Technical Service Bulletin

No. D71-1-6

Radio Noise

MODELS: 1971
Coronet and
Charger So
Equipped
P-1476-C

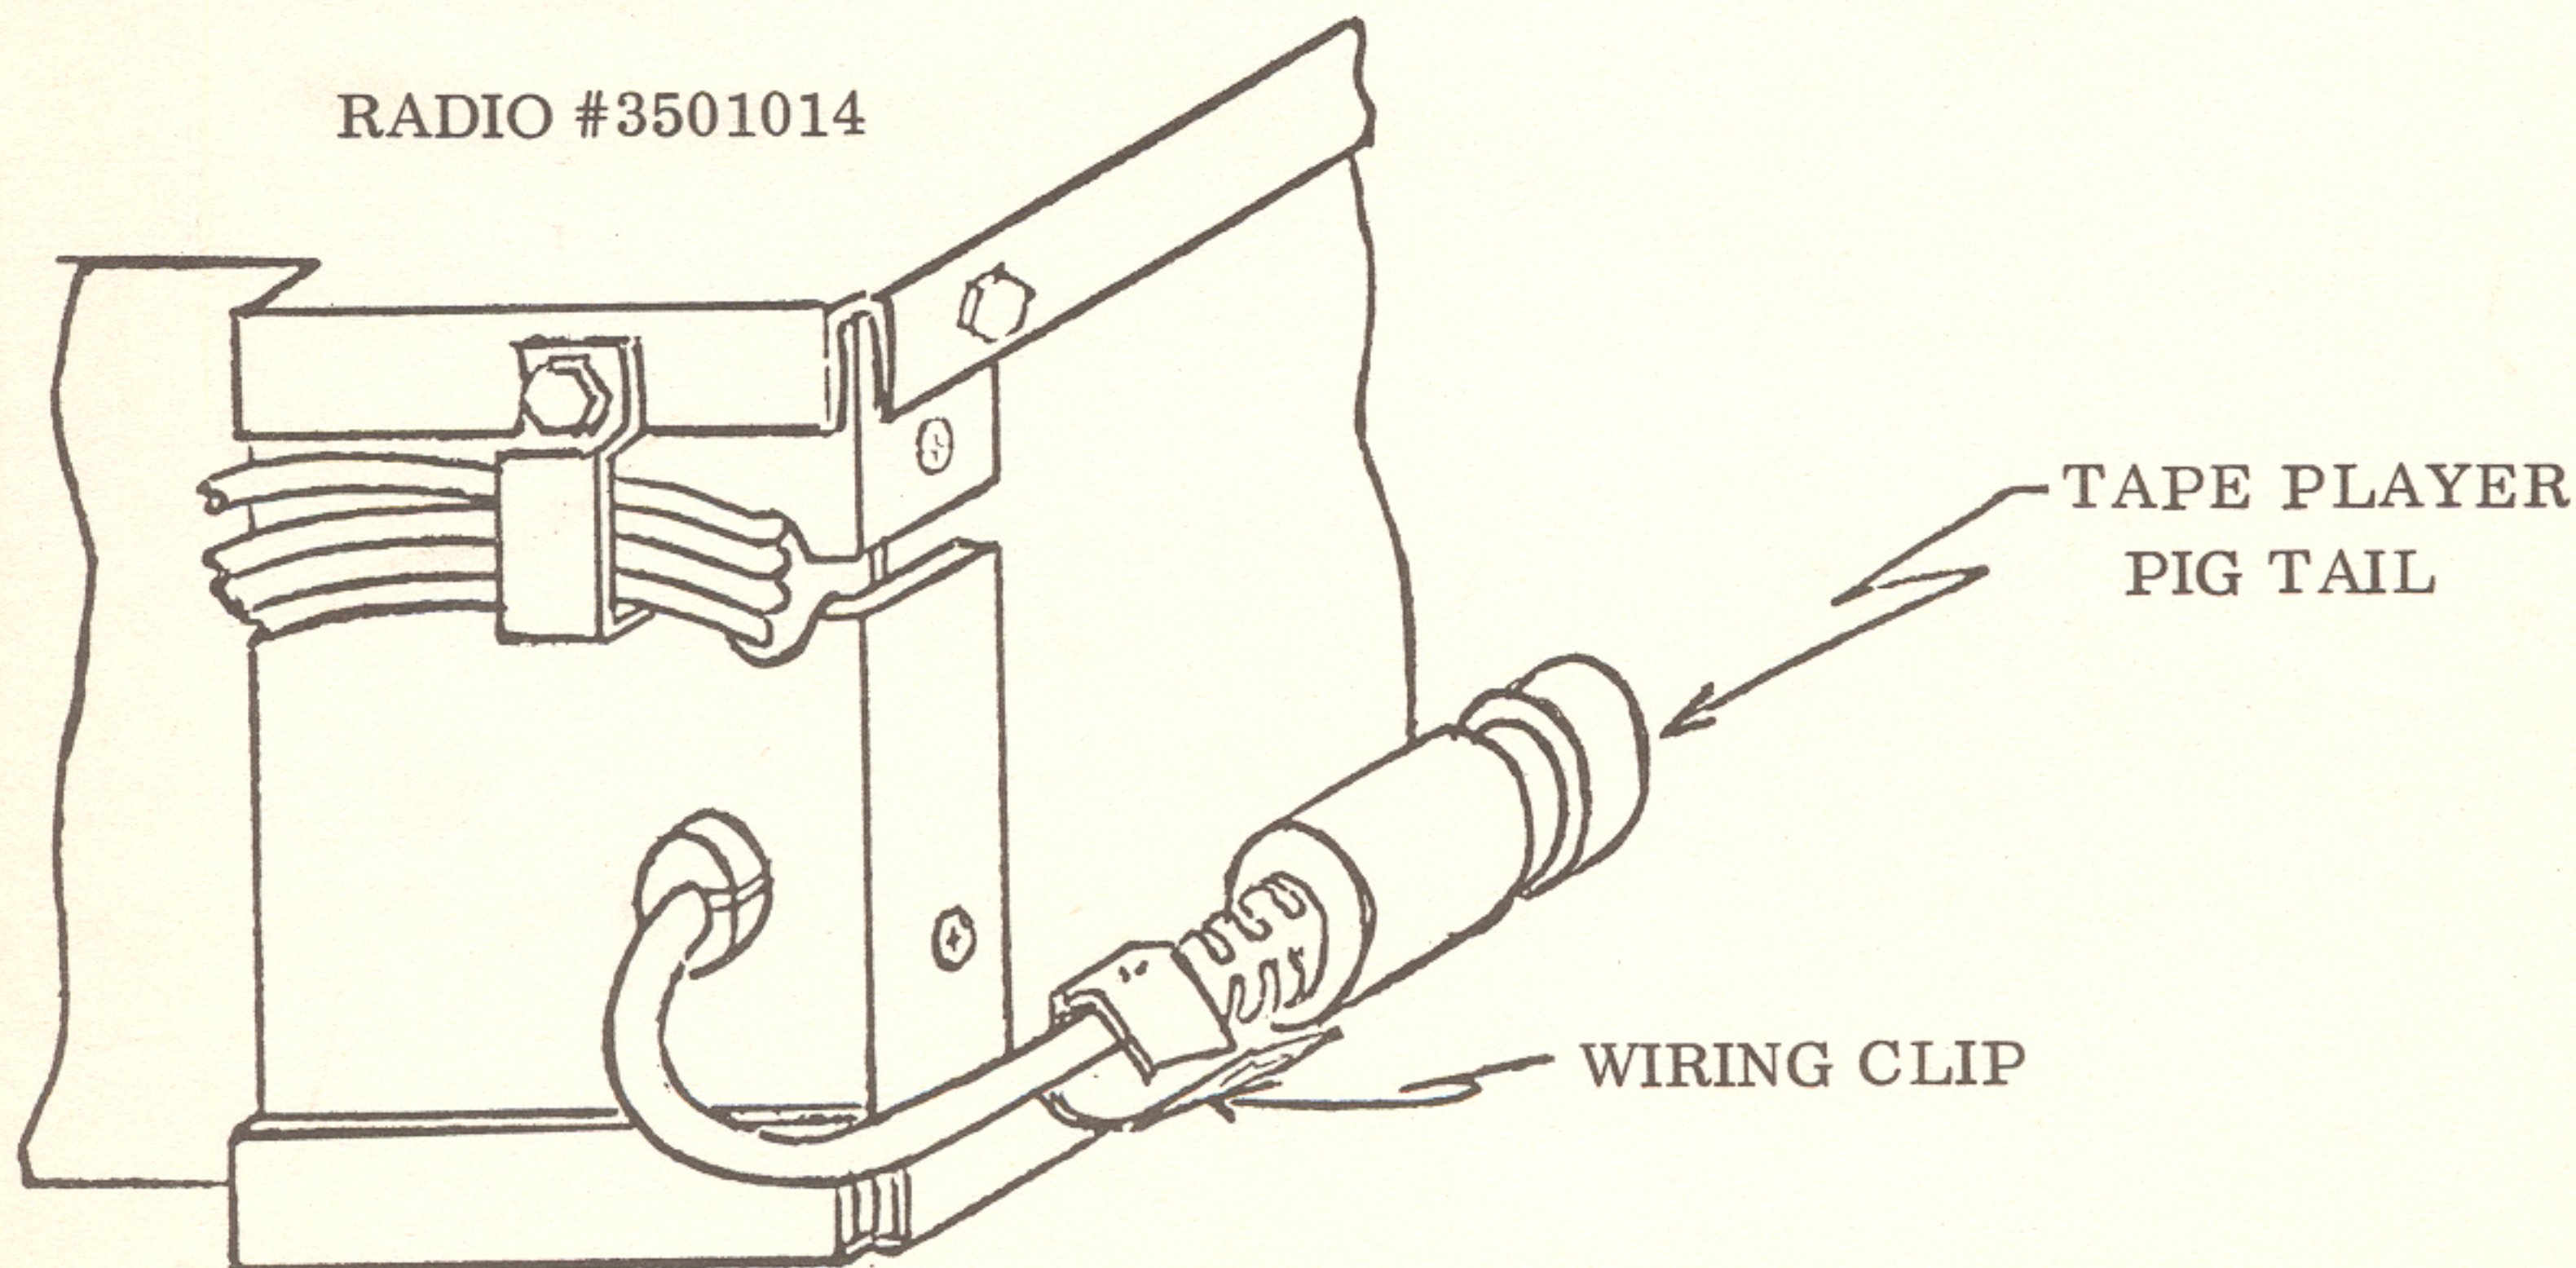
Complaints of ignition noise with AM/FM/MX radio, Mark I (Part No. 3501014) in 1971 cars, may be caused by the location of the tape player pig tail to the car wiring (see illustration). The pig tail performs like an antenna, and transmits the ignition noise from the car wiring to the radio system.

In order to minimize this noise, relocate the pig tail cable by adding an additional wiring clip, as shown in the illustration.

Mark I radios have a wiring clip now near the antenna ferrule. Remove and relocate this clip or fabricate one as shown in illustration.
